IDAP REPORT

Property:	26 Glenarvon Street STRATHFIELD LOT 1 DP 14865 DA2021.200
Proposal:	Demolition of existing structures on site and construction of a two (2) storey dwelling house with in-ground swimming pool, front fence and associated landscaping works.
Applicant:	H.A Design Group
Owner:	M Komala and N Komala
Date of lodgement:	17 August 2021
Notification period:	23th August 2021 – 8th September 2021
Submissions received:	Nil
Assessment officer:	L Fanayan
Estimated cost of works:	\$1,065,465.00
Zoning:	R2-Low Density Residential - SLEP 2012
Heritage:	No
Flood affected:	No
Is a Clause 4.6 Variation Proposed:	No
RECOMMENDATION OF OFFICER:	APPROVAL

Figure 11: Void spaces adjacent to the stairwell and above dining room.

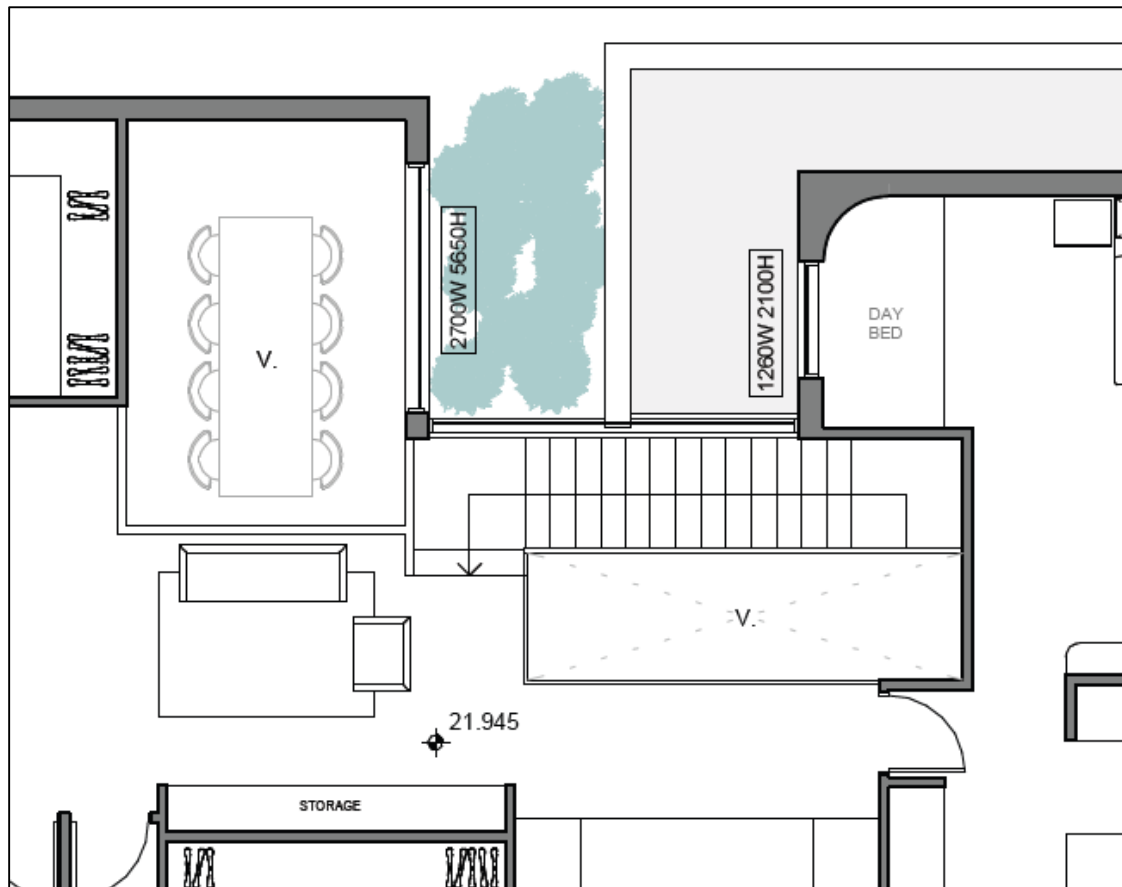
The void spaces included in the first floor of the design are considered reasonable and acceptable. These voids relate to the stairwell and the dining room (refer to Figure 11). The void above the formal dining room provides additional solar access and amenity for this room and the surrounding ground floor areas. It is also noted that any bulk and presentation by this void space will primarily affect the side boundary of No. 28 Glenarvon Street. The 1.73m setback of the building combined with the void glazing facing away from the side boundary will minimise the impact on the neighbouring property.

To ensure that the void space above the formal dining room remains a void an ongoing condition will be included in the consent.

Figure 12: South Elevation showing pool and alfresco area height above ground.

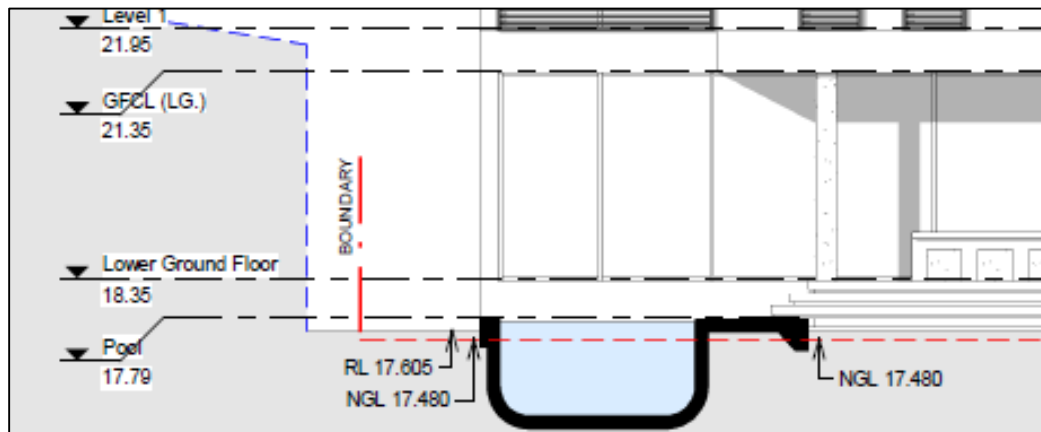
The pool has been stepped down 0.55m from the alfresco area to reduce overlooking and privacy impacts on the adjoining neighbour at 28 Glenarvon Street and 63 Augusta Street. The pool and associate copping will be 0.31m above NGL and 0.185m above RL. Further, privacy has been enhanced with screen planting proposed on the boundary of the private open space.
